User Safety Notice

30 ft. / 9 m. Workman® Self-Retracting Lanyard

October 28, 2015

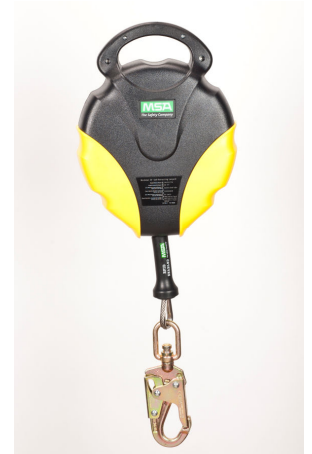
We have determined that a small percentage of Workman 30 ft. / 9 m. SRLs manufactured from January through August of 2015 may have an improper brake nut torque setting. This condition is not detectable when performing the normal pre-use inspection procedure. SRLs with this condition may not arrest a user's fall or may not arrest it within the specified maximum arrest distance.

To identify affected 30 ft. / 9 m. Workman SRLs, check the label affixed to the unit. Affected SRLs have one of the following "model" numbers and the "date made" is from 01-2015 through 08-2015:

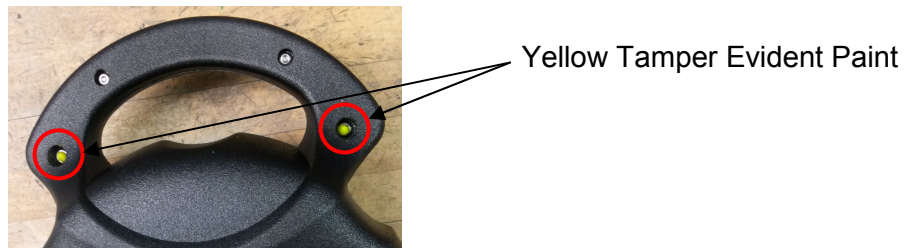
Please note that the replacement SRLs may also have a “date made” from 01-2015 through 08-2015, but include yellow tamper evident paint on the exterior housing screw heads near the handle, as shown in the photo below. These SRLs are new units that were factory upgraded to include a new brake assembly and are acceptable for use.
